Local Grant Identification for EPOC TDD (baseline proposal amendment)

Andrea Garavaglia and Patrick Stupar
(Qualcomm)

Gate processing in CLT for local (TDD) grant

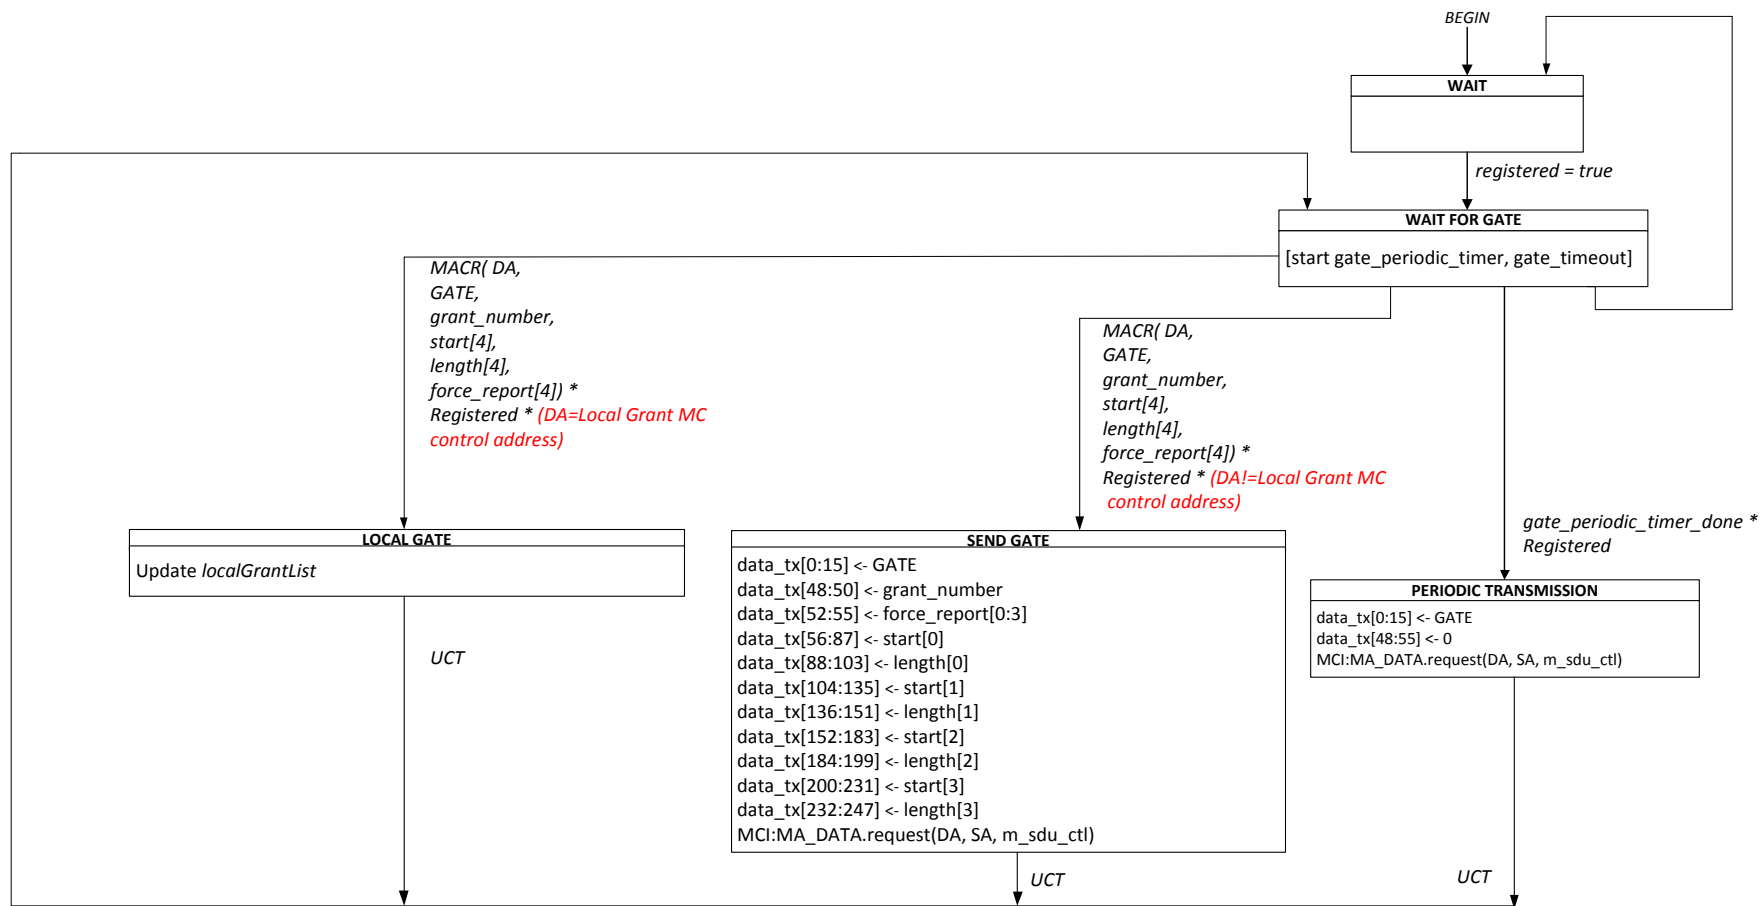
In the current design, the DA is used to identify a Local Grant from a CNU Grant (see red boxes above).

Comment: the Destination Address (DA) for non-discovery GATE in the *MA_CONTROL.request* primitive is defined in IEEE 802.3 Clause 77.3.3.5 as “Multicast MAC Control address as defined in Annex 31B”.

Solution #1: definition of a new MAC control address

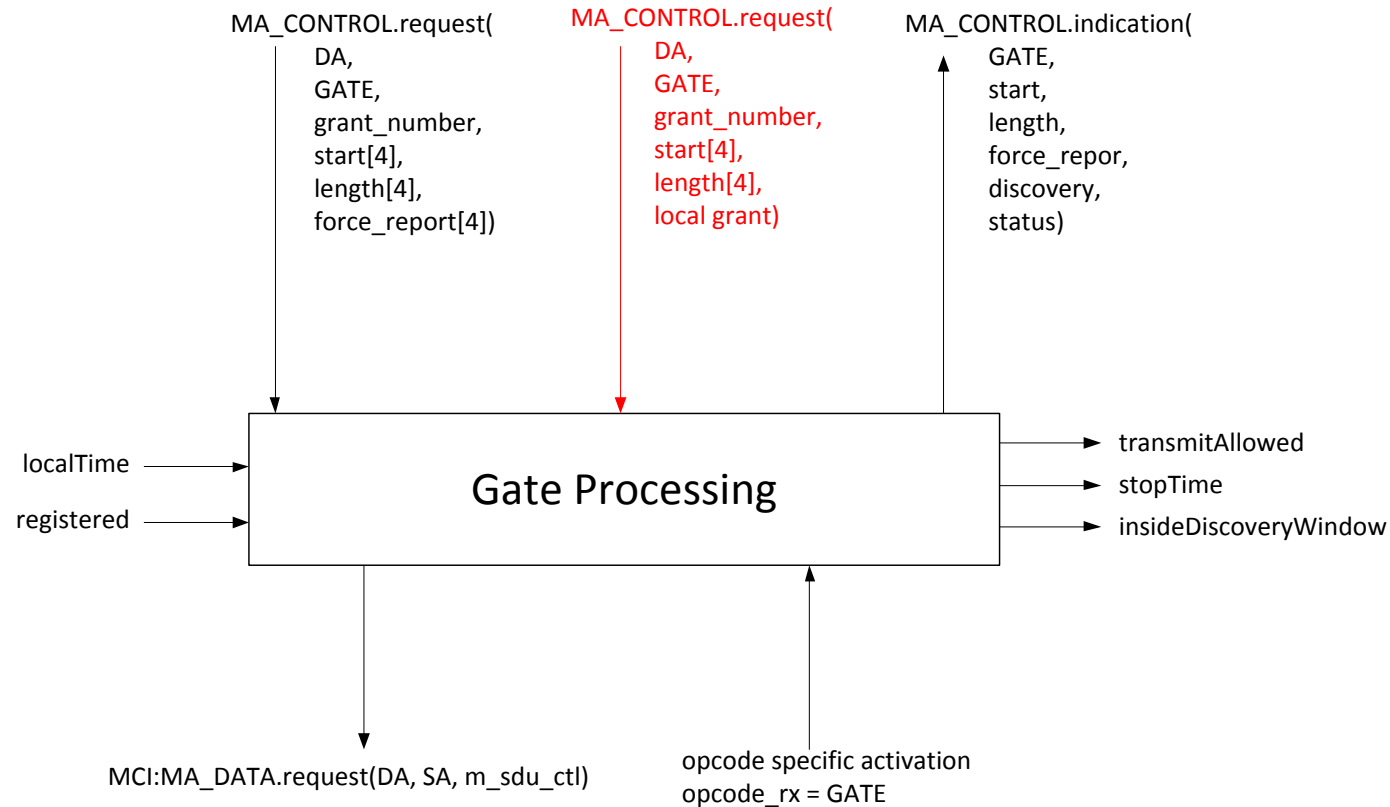
Definition of new MAC control multicast address (e.g. 01-80-C2-00-00-02) and extension of the *MA_CONTROL.request* primitive

MA_CONTROL.request (DA, GATE, grant_number, start[4], length[4], force_report[4]). This request primitive is used by the MAC Control client at the CLT to issue the GATE message to an CNU and to issue local grants for downstream transmission in TDD mode.

- DA: Multicast MAC Control address as defined in Annex 31B (if the primitive is used to issue the GATE message) or Multicast MAC Control address as defined in XX (if the primitive is used to issue the local grant GATE)
- GATE: Opcode for GATE MPCPDU as defined in Table 31A–1.
- grant_number: Number of grants issued with this GATE message. The number of grants ranges from 0 to 4.
- start[4]: Start times of the individual grants. Only the first grant_number elements of the array are used.
- length[4]: Lengths of the individual grants. Only the first grant_number elements of the array are used.
- force_report[4]: Flags indicating whether a REPORT message should be generated in the corresponding grant. Only the first grant_number elements of the array are used.

Solution #2: Definition of a local grant primitive

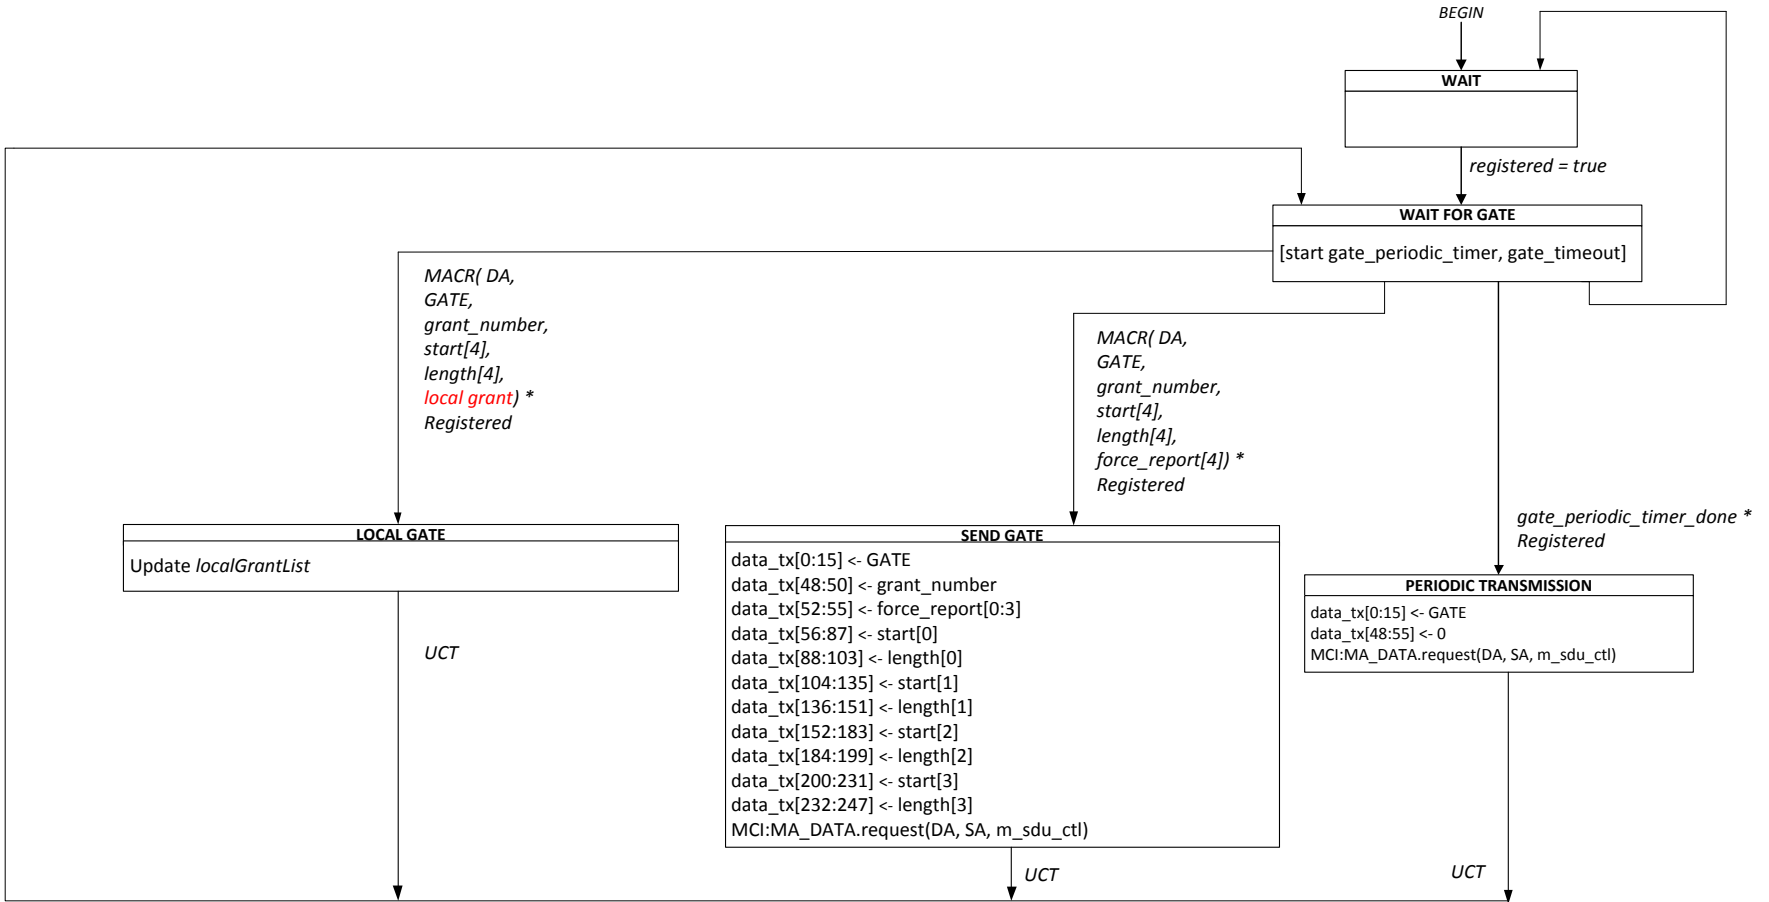
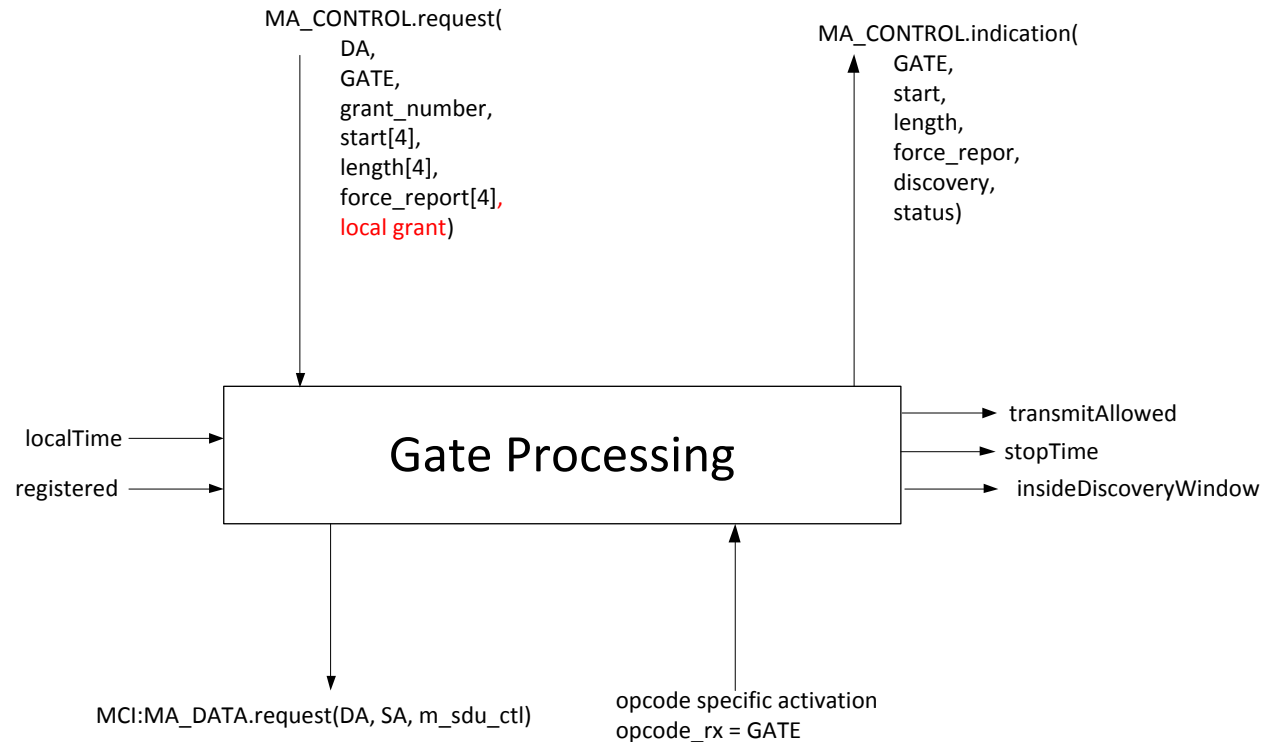
Two different service primitives entries in Gate processing block (one for local grant GATE and one for GATE messages transmission)

GATE primitive for local grant is defined in a similar way as GATE primitive for discovery
Note: the state machine for local grant *MA_CONTROL.request* request primitive may be defined separately

MA_CONTROL.request(DA, GATE, grant_number, start[4], length[4], **local_grant**). This request primitive is used by the MAC Control client at the CLT to issue local grants for downstream transmission in TDD mode.

- DA: Multicast MAC Control address as defined in Annex 31B
- GATE: Opcode for GATE MPCPDU as defined in Table 31A–1.
- grant_number: Number of grants issued with this GATE message. The number of grants ranges from 0 to 4.
- start[4]: Start times of the individual grants. Only the first grant_number elements of the array are used.
- length[4]: Lengths of the individual grants. Only the first grant_number elements of the array are used.
- **local_grant**: **Flag specifying that the given GATE message is to be used for local grant only**

Note: the new local_grant flag is absent for other grants

Solution #3: Extension of the existing primitive

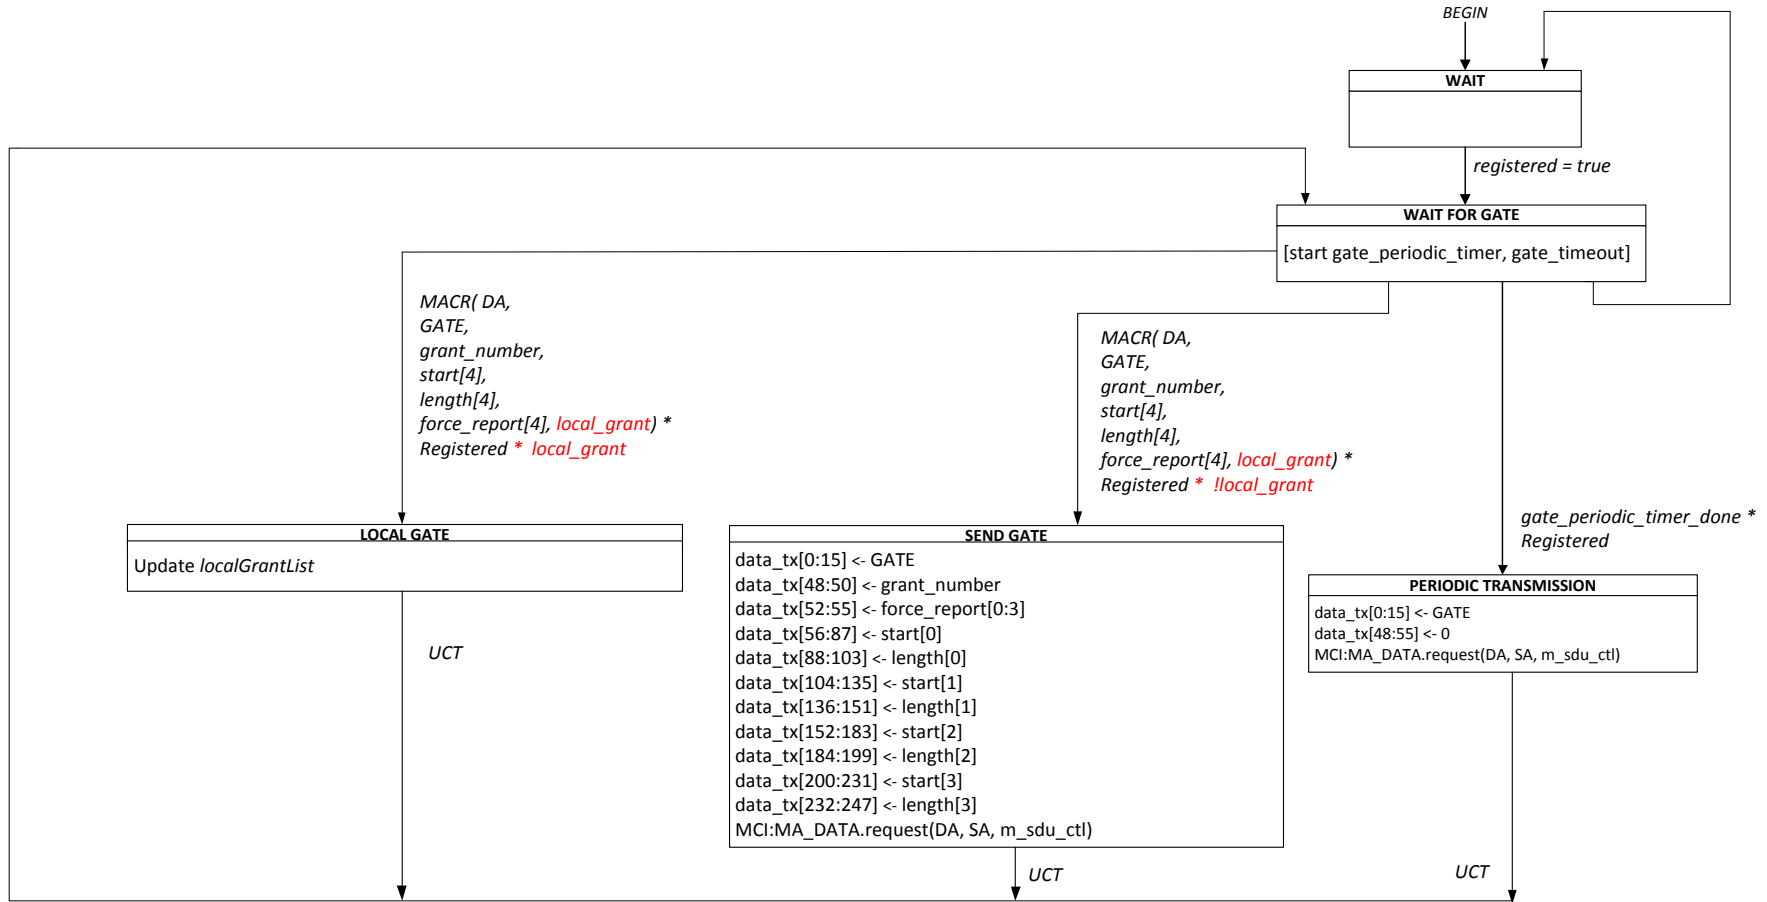
Just one request primitive entry in GATE processing block, applicable to both local and remote grants. The new boolean variable *local_grant* is used to distinguish the local grant from other grants.

Existing MACR request primitive is extended by addition of a new optional boolean variable named *local_grant*, with default value = FALSE unless explicitly set.

MA_CONTROL.request(DA, GATE , grant_number, start[4], length[4], force_report[4], **local_grant**). This request primitive is used by the MAC Control client at the CLT to issue local grants for downstream transmission in TDD mode.

- DA: Multicast MAC Control address as defined in Annex 31B
- GATE: Opcode for GATE MPCPDU as defined in Table 31A–1.
- grant_number: Number of grants issued with this GATE message. The number of grants ranges from 0 to 4.
- start[4]: Start times of the individual grants. Only the first grant_number elements of the array are used.
- length[4]: Lengths of the individual grants. Only the first grant_number elements of the array are used.
- force_report[4]: Flags indicating whether a REPORT message should be generated in the corresponding grant. Only the first grant_number elements of the array are used.
- **local_grant**: **Boolean variable specifying whether the given grant is a local grant (when set to TRUE) or not (when set to FALSE). Default value is FALSE.**
